RE: Proposed redevelopment of Trinity Grammar School SSD-10371

Thank you for the opportunity to provide a submission on the above development.

Figure 1: VP15B View impact assessment (Appendix 11, p53)
View from first floor bedroom standing at window of
157 Victoria Street (50mm lens used for emphasis)

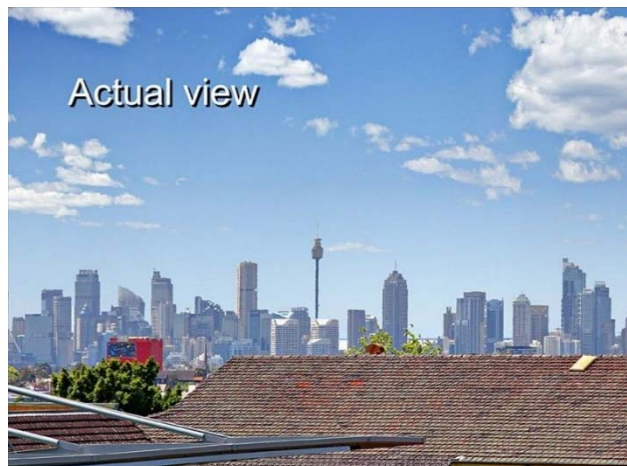
The View Impact Assessment (Appendix 11, Page 22) stated that there “would be no loss of view of items identified as valued, in Step 1 of Tenacity”. Sufficient evidence to demonstrate the accuracy of this statement was not provided.

There are obvious discrepancies in the two photos taken from the exact same location (first floor of 157 Victoria Street). It is significant that VP15B is the only photo in the Visual Impact Assessment that required a “50mm lens used for emphasis” and photomontage and view in place data sheets were omitted from the Appendix.

My residence at 159 Victoria Street currently enjoys similar CBD skyline views (as shown in Figure 3). I welcome the provision of a photomontage and a view in place data sheet of existing CBD skyline views from the first floor of my residence to demonstrate the impact of SSD-10371 and provide evidence that the planning principles outlined in Tenacity have been applied in a clear and transparent manner.
